July 16, 2024

Re: Initial Submission Review: Green Valley Ranch East – Site Plan No. 19, Plat Vacation and Plat
Application Number: DA-1662-35
Case Numbers: 2021-4010-01; 2021-3017-01; 2024-3030-00

Initial Submission Review

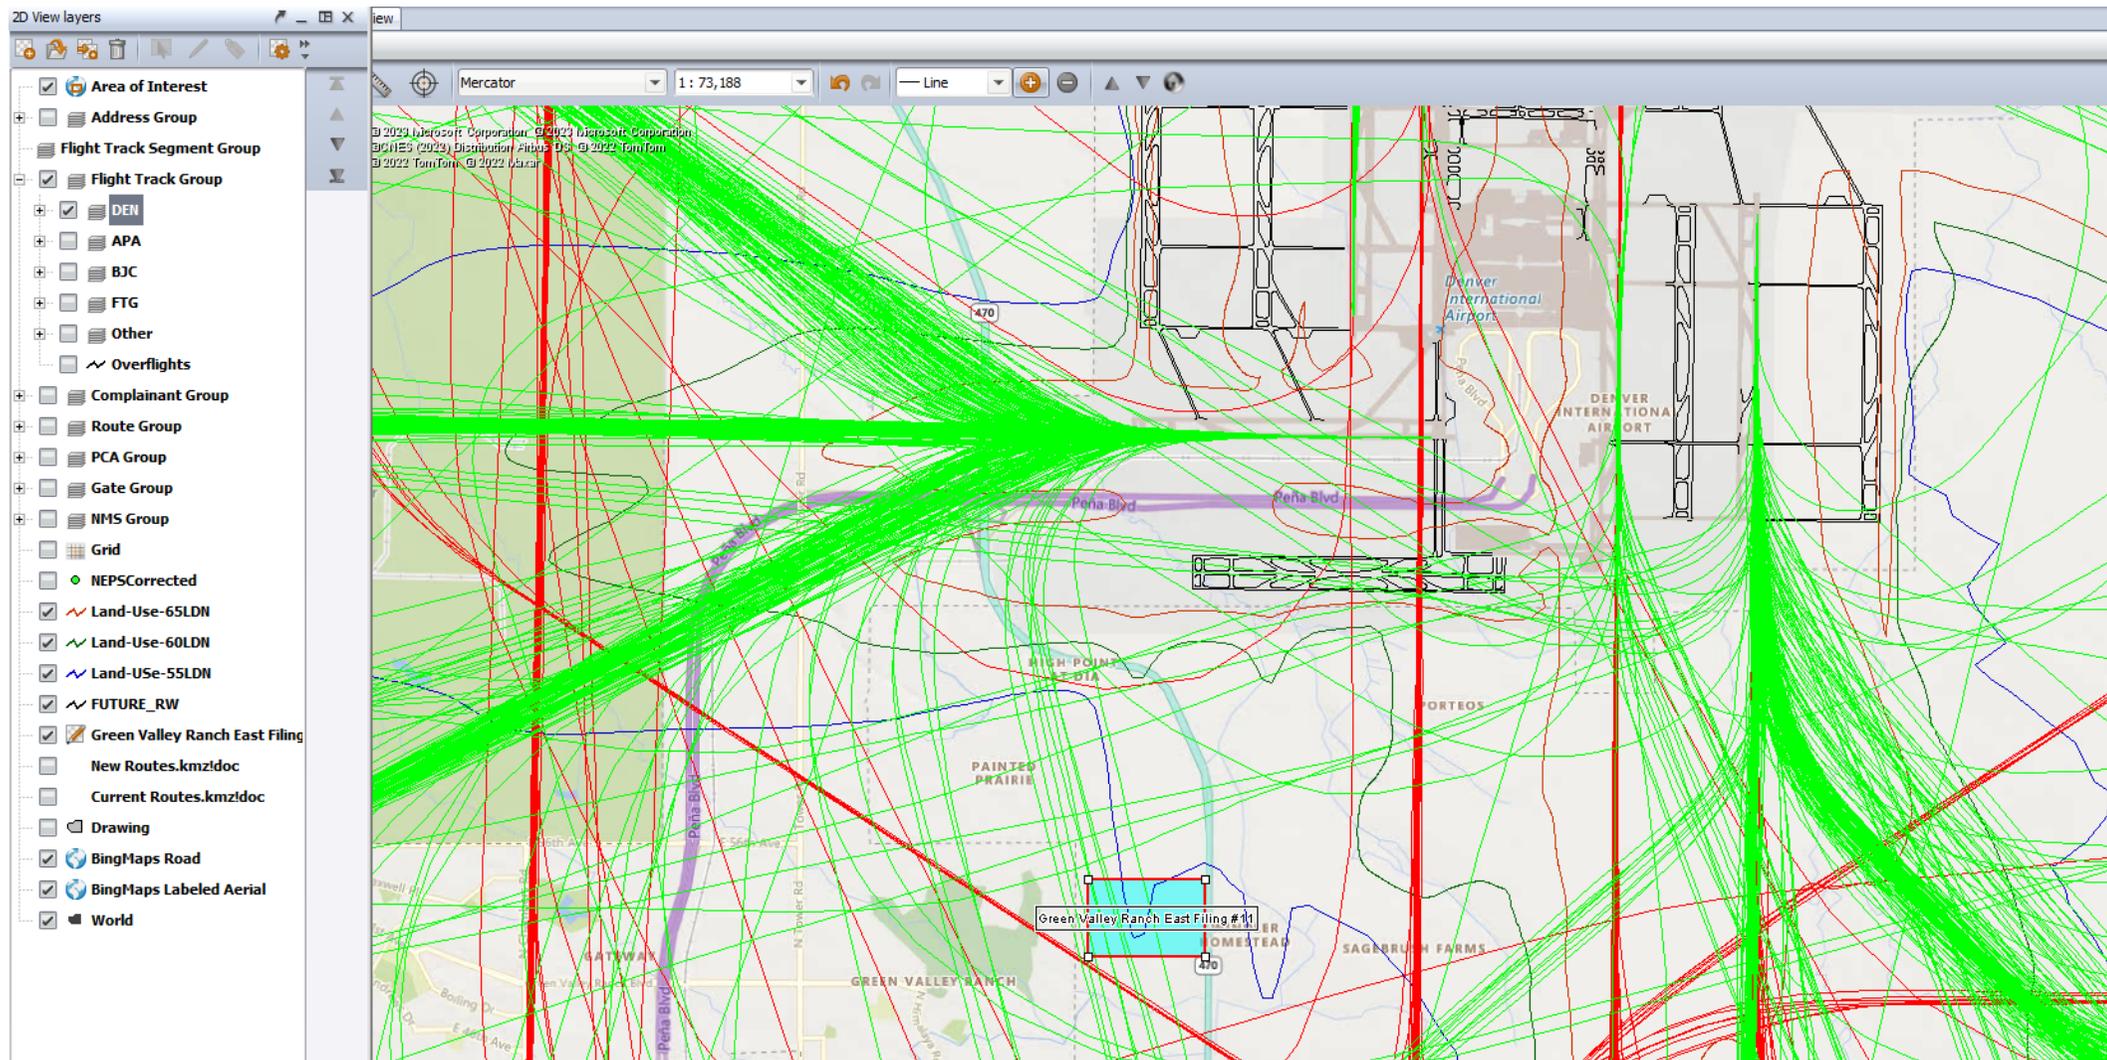
Other developments in this area have been reviewed previously, and the noise analysis still holds true. While this park area is not currently under an arrival pattern, the future north-south runways on the west side of the airfield will put arrivals over the subject property. This portion of the development could potentially have arrival overflights from the south at altitudes of between 1,500 feet above ground level (AGL) and 4,100 feet AGL depending on the aircraft type and what arrival runway the Federal Aviation Administration (FAA) air traffic controllers have directed the aircraft to land on. If the winds are out of the north aircraft will land coming in from the south on final approach to DEN. Aircraft currently arrive to DEN on runways 34L and 34R and with the potential of 4 North/South runways on the West side of the airfield there could be even more daily arrival overflights of this development. The future runways are depicted in black on this map of flight data from 2/28/23. This day's flights depicts a typical flight pattern for a 24 period.

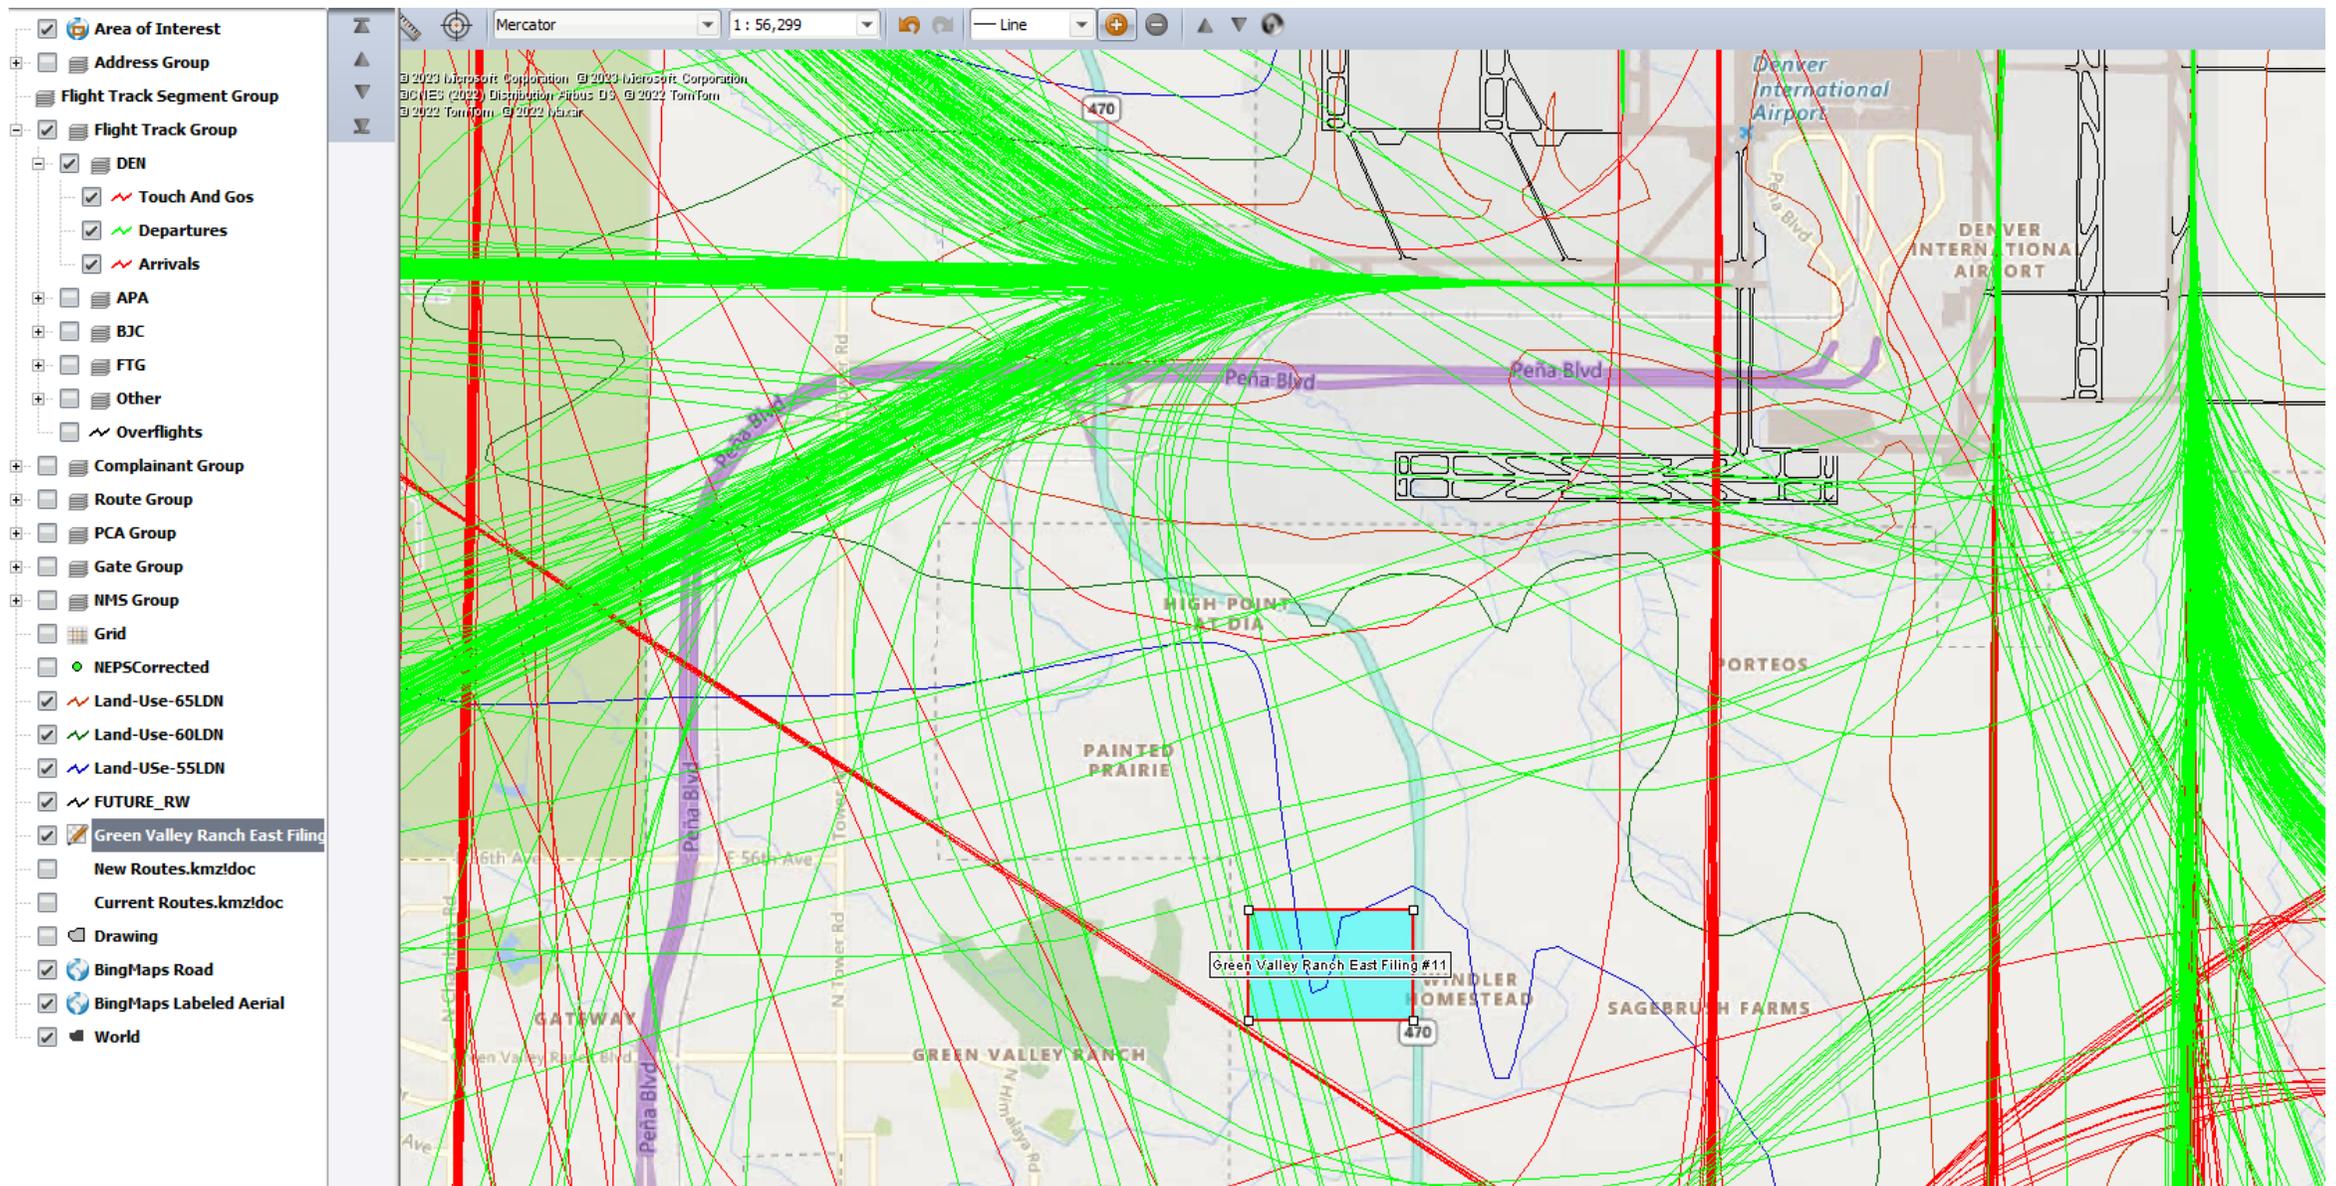
Same flight data from 2/28/23, zoomed in to see the 55, 60 and 65 DNL contour and the property area in light blue. The 55 DNL intersects the property on the north end. This portion of the 55 DNL pertains to the additional 2 potential north/south runways on the west side of the airfield. Once the runway straight north of this property is built, 16C/34C (might be the runway names) there will be overflights at the beforementioned altitudes. There could be upwards of 200+ arrivals per day to those future runways.

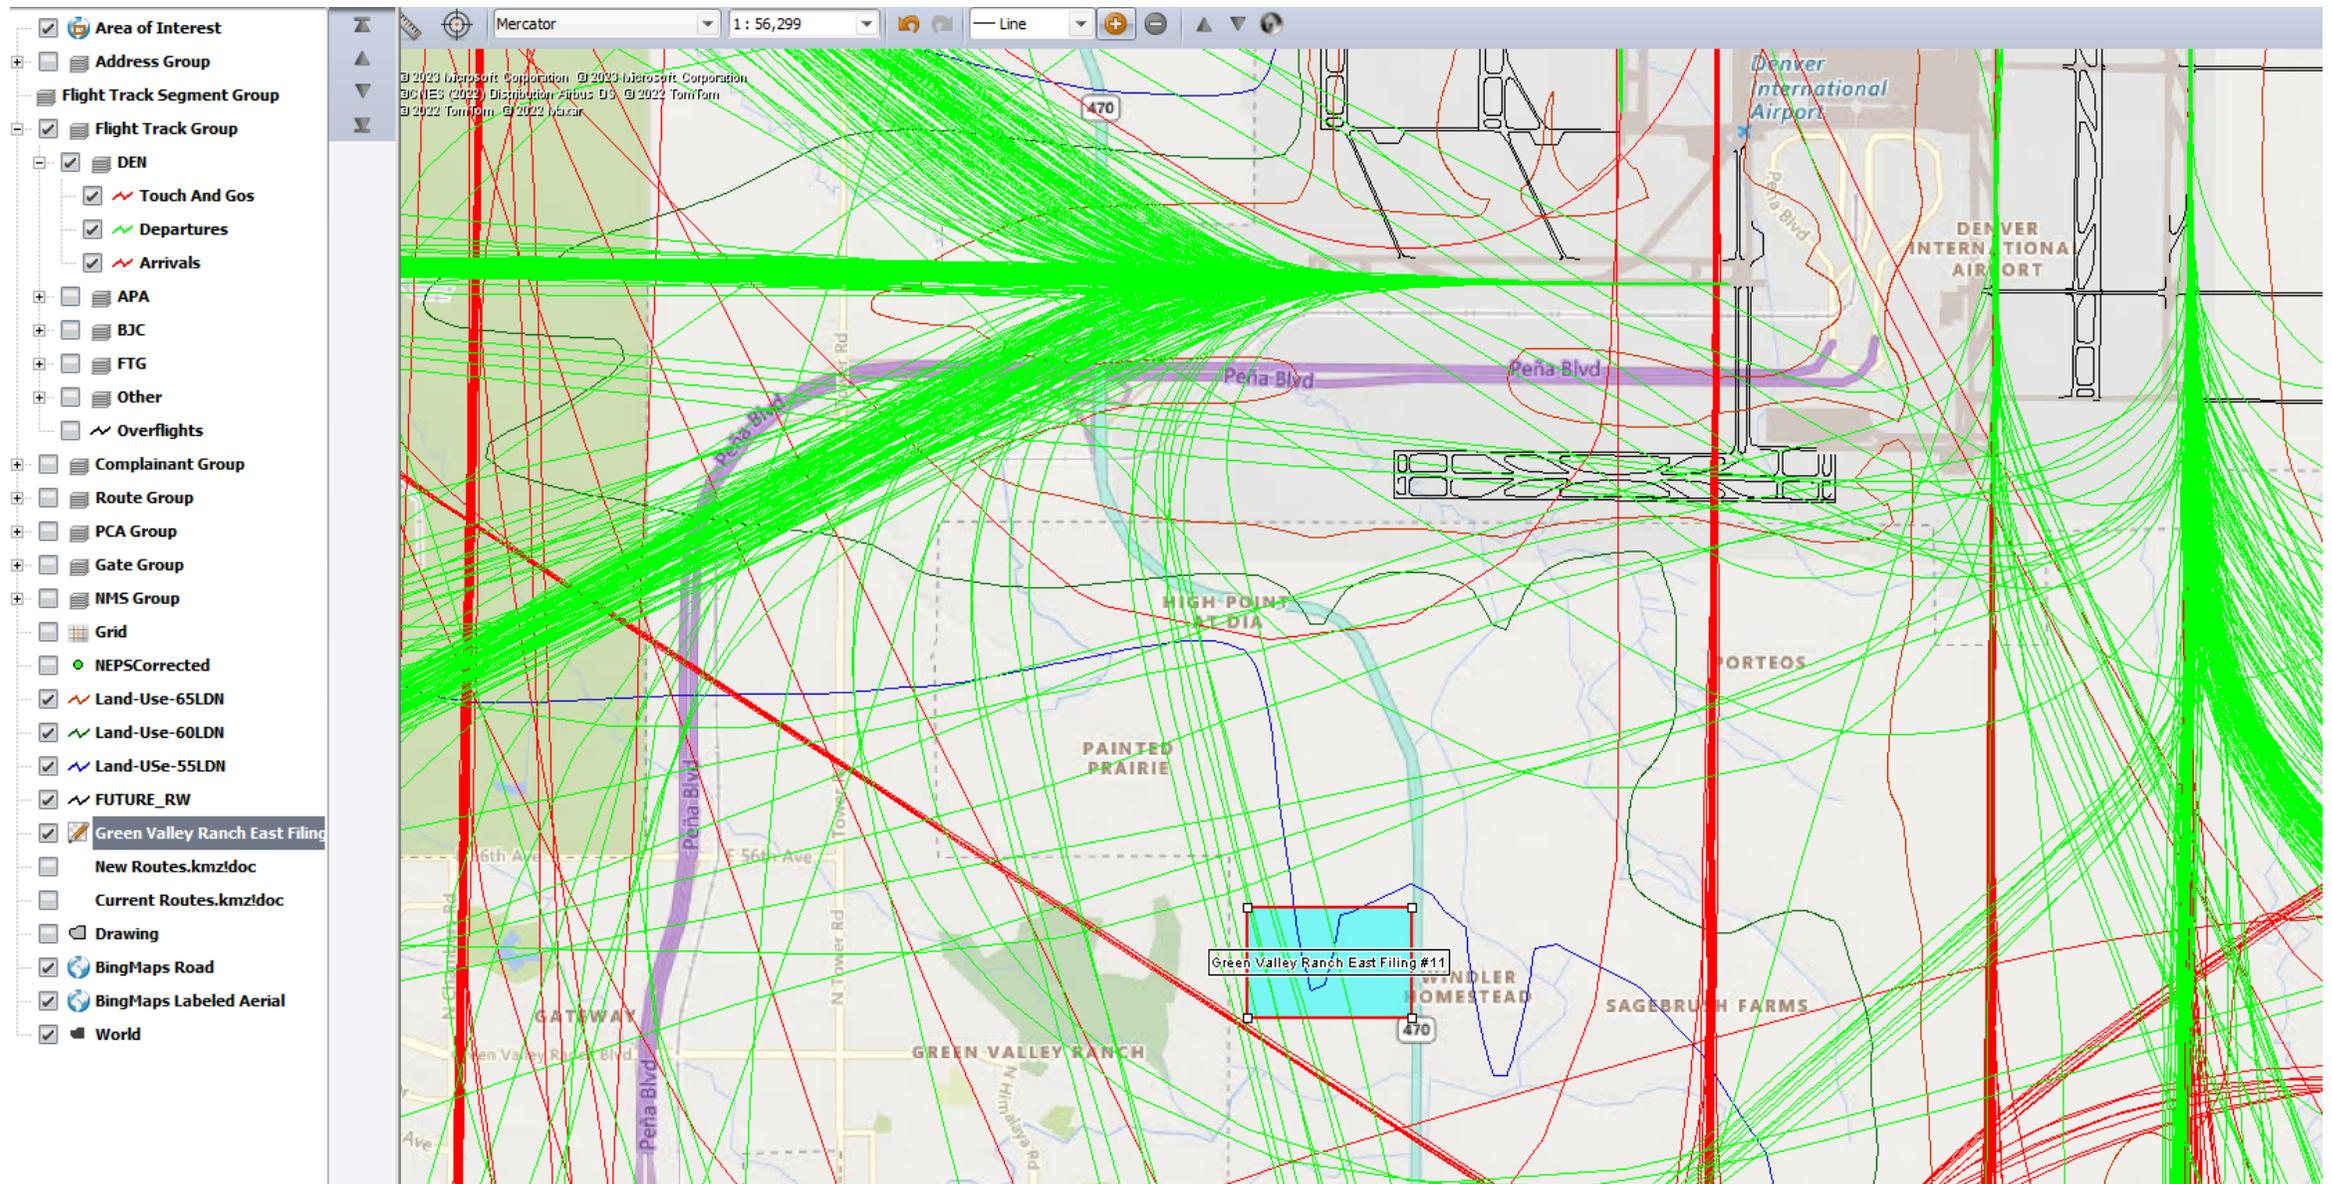
Flight data from 2/28/23. Few arrivals vectoring to get in line for final approach to 34L or 34R and there are also some departures that could fly near the subject property. On this day there were a few departures from runway 17L and 17R as well as runway 25. Their altitudes can vary based on aircraft type. On this day they were between 2,600 feet AGL and 4,100 feet AGL. These aircraft will be louder than arrivals as they are under full power departing DEN. During periods of high winds, inclement weather or runway capacity issues the FAA will depart aircraft to the south from runways 17L/R and then turn them west to get back onto the final assigned pattern. This could happen from any one of the north south runways. For the same reasons noted above, the FAA will direct departures from runway 25 to depart west and the turn to the south to then get them onto their final assigned pattern.
